Access Compliance Report

Public Rights-of-Way

(Curb Ramps)

Intersection ID: 17302	Main Street: LINDA_LN	Cross Street: WATER_OAK_RD	Location: NE
ADA ID: 450EAE64A990	Ramp Type: PerpDiag	Initial Pass/Fail: Fail	Overall Compliance: No
		Severity Score: 25

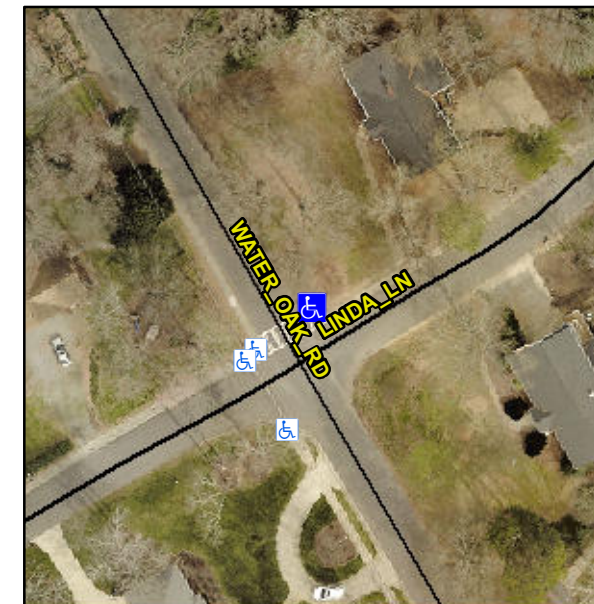
Compliance	Description	Data	Compliance	Description	Data
N/A	Ramp Length (in)	38.0	No	Ramp Slope (%)	12.2
Yes	Ramp Width (in)	58.0	Yes	Ramp XSlope (%)	0.5
N/A	Flare Type LT	N/A	N/A	Flare Type RT	N/A
N/A	Flare Slope LT (%)	N/A	N/A	Flare Slope RT (%)	N/A
N/A	Flare Traversable LT?	N/A	N/A	Flare Traversable RT?	N/A
N/A	Landing Length (in)	N/A	N/A	DWS Provided?	N/A
N/A	Landing Width (in)	N/A	N/A	DWS Contrast?	N/A
N/A	Landing Slope (%)	N/A	N/A	DWS Length (in)	N/A
N/A	Landing X Slope (%)	N/A	N/A	DWS Full Width?	N/A
N/A	Landing Curb? (Y/N)	N/A	N/A	DWS Offset (in)	N/A
N/A	Shared Landing?	N/A			
N/A	Gutter Ponding?	N/A	N/A	Gutter Slope (%)	N/A
N/A	Gutter Lip Ht (in)	N/A	N/A	Gutter X Slope (%)	N/A
N/A	Painted X Walk1?	Yes	N/A	Painted X Walk2?	No
	X Walk 1 Direction	To SW		X Walk 2 Direction	To S
N/A	X Walk 1 Width (in)	118.0	N/A	X Walk 2 Width (in)	N/A
	X Walk 1 Slope (%)	1.5		X Walk 2 Slope (%)	3.8
	X Walk 1 X Slope (%)	2.6		X Walk 2 X Slope (%)	3.2

Remove & Replace Curb Ramp With Two New Directional Ramps or Equivalent.
